ADDENDUM # 1 - PAGE 1 of 10

RFP TITLE: PASO REAL DRAINAGE IMPROVEMENTS PROJECT

RFP NUMBER # 230801

PASO REAL DRAINAGE IMPOROVEMENTS - RESPONSE TO RFI

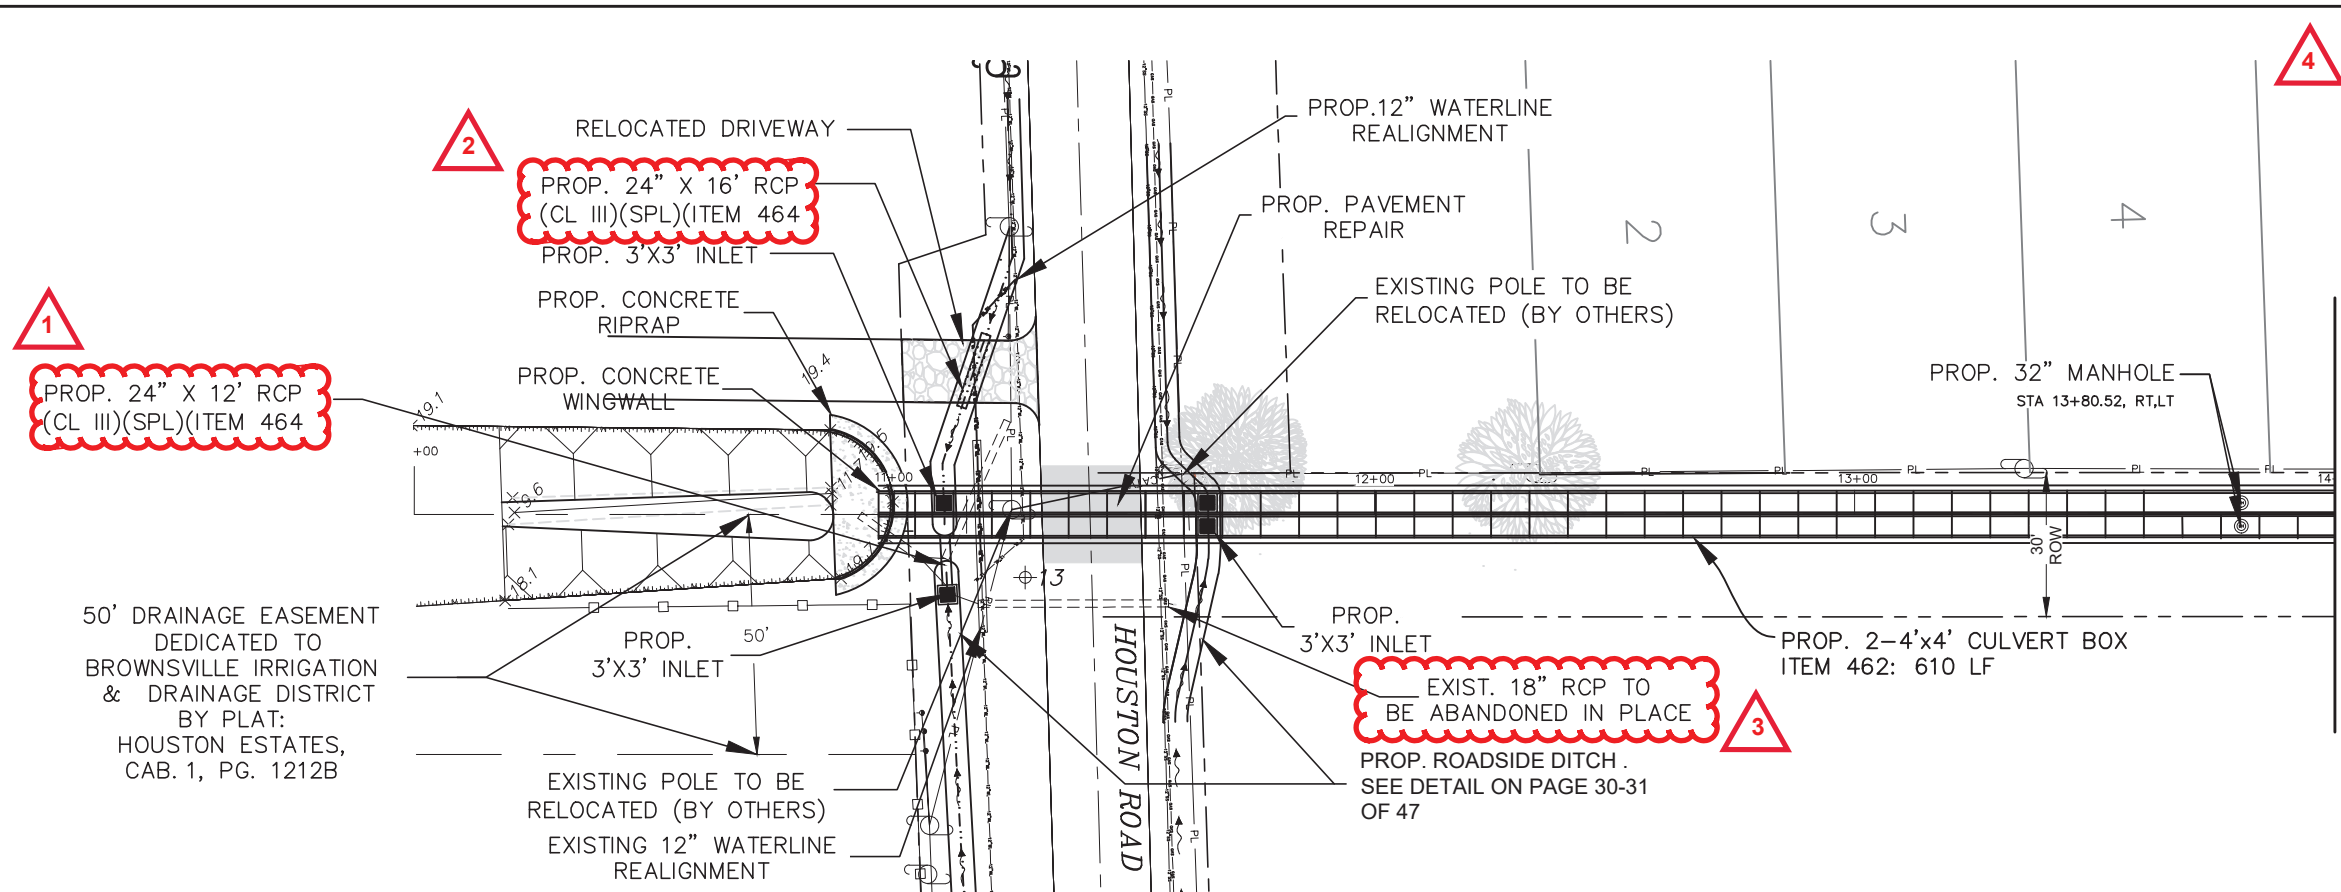
QUANTITIES REVISED 7-28-23

STA 10+00 TO 14+00
PLAN & PROFILE

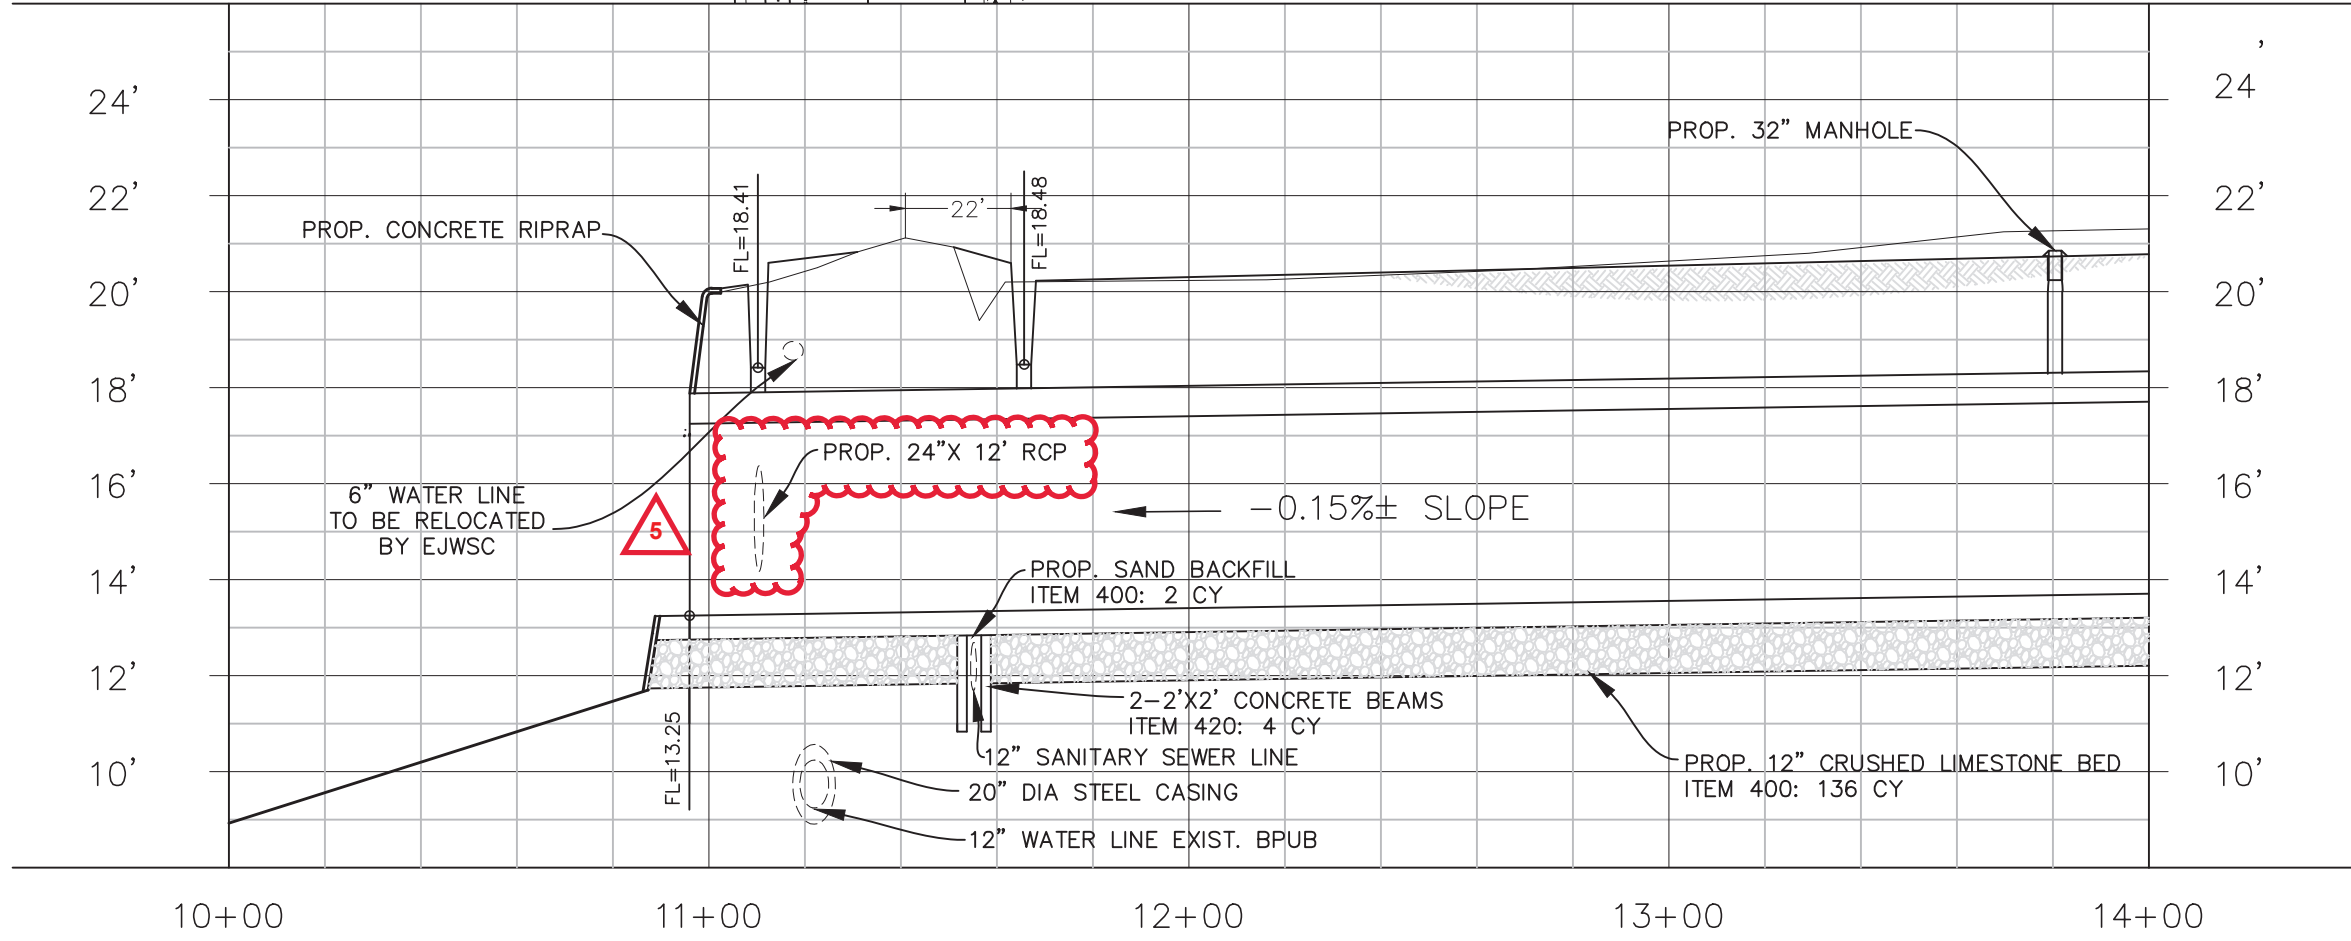
- 1 CALL-OUT ADDED 7-28-23
- 2 CALL-OUT ADDED 7-28-23
- 3 CALL-OUT ADDED 7-28-23
- 4 QUANTITIES REVISED 7-28-23
- 5 PROP. PIPE SHOWN 7-28-23

ASPHALT STABILIZED CUT & RESTORE

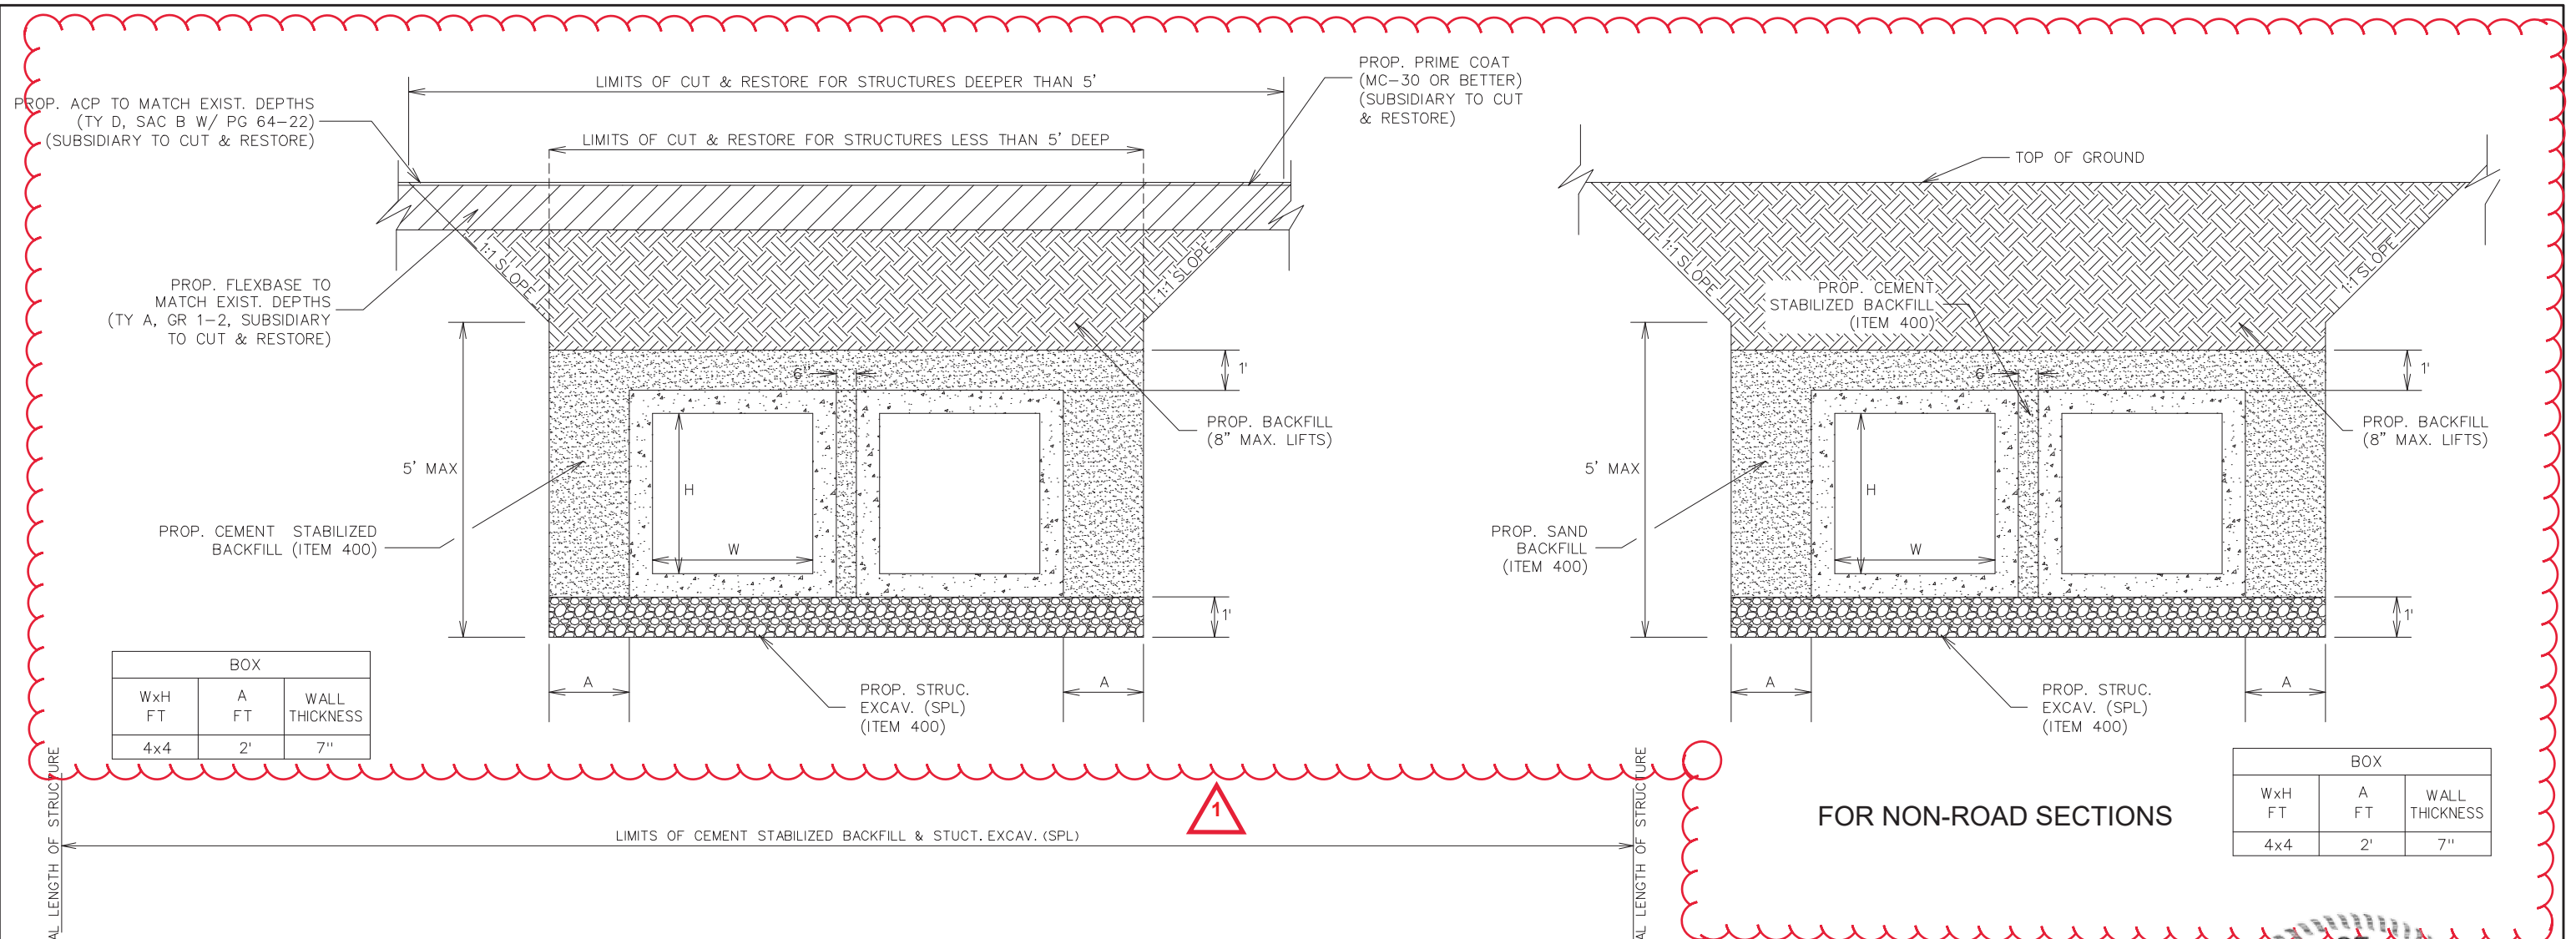
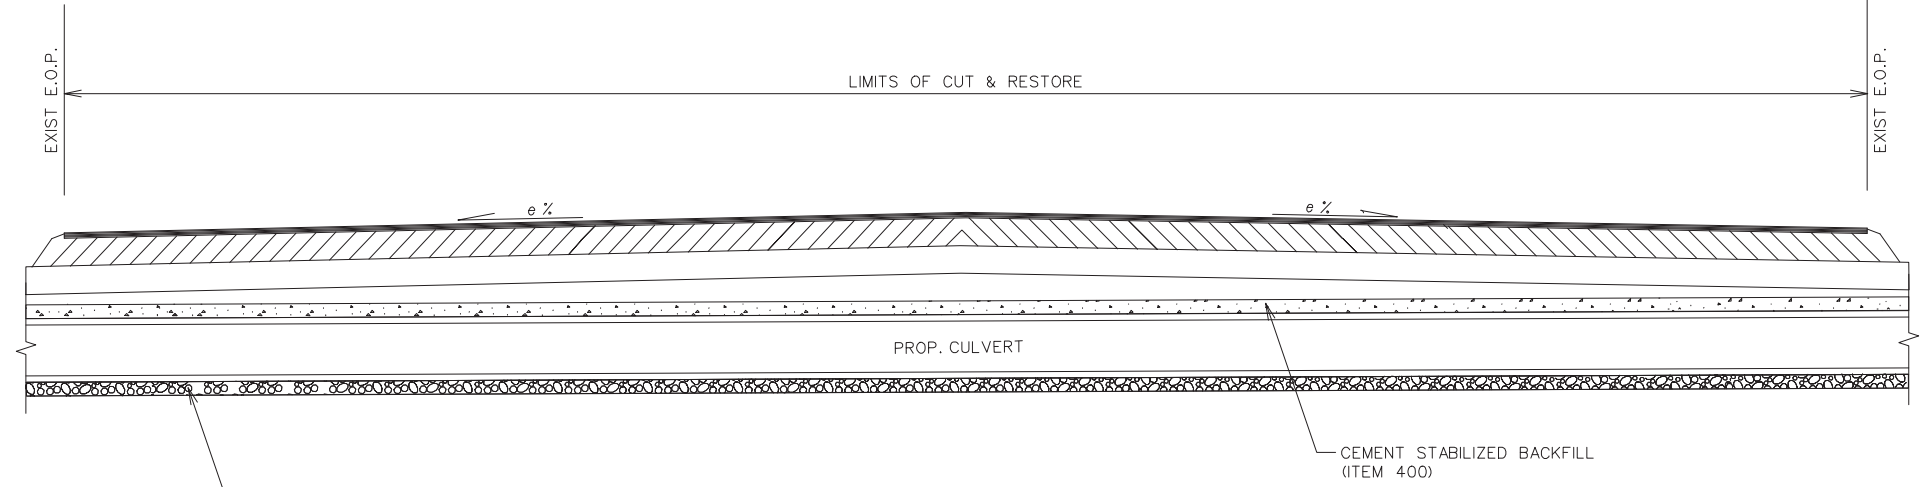
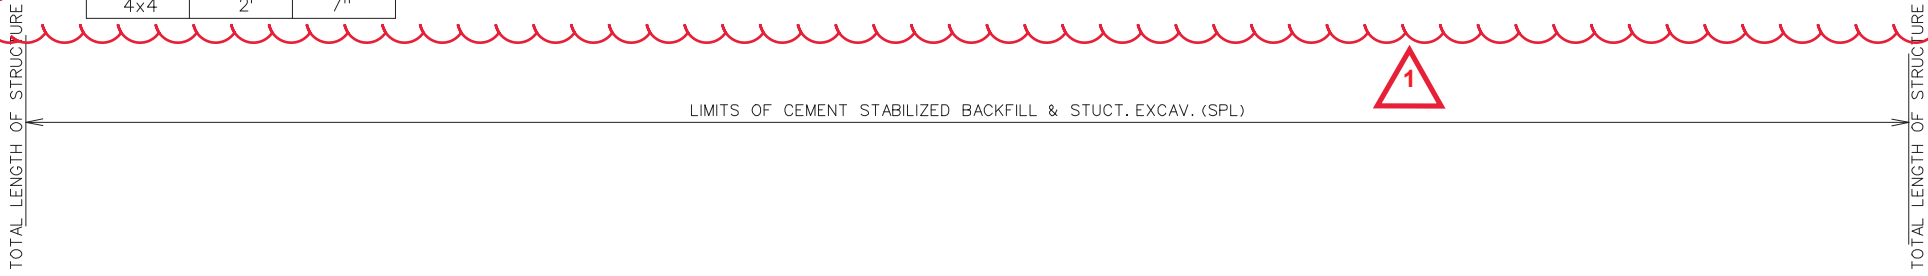
1 DETAIL REVISED (1) AND ADDED (1) 7-28-23
